DS DS	DRAWN BY	DART AEROSPACE LTD VICTORIA INTERNATIONAL AIRPORT, CANADA	
CHECKED	APPROVED	DEO 9094 SHEE	REV. A
97. 10. 2	2	TOW RING DRILLING CHANGE	SCALE NTS

## DART ENGINEERING ORDER

TO AMEND DRAWINGS: D2580 REV. B

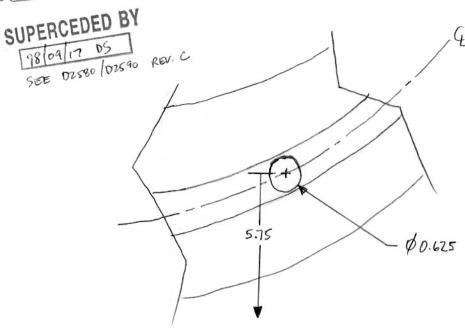
- DRILL TOW RING HOLE IN SAME LOCATION SPECIFIED BY DRAWINGS D2580 AND D2590.
- DRILL TO NEW DIAMETER OF 0.625
- DO NOT WELD IN DZ579 CROSS BOLT SPACER
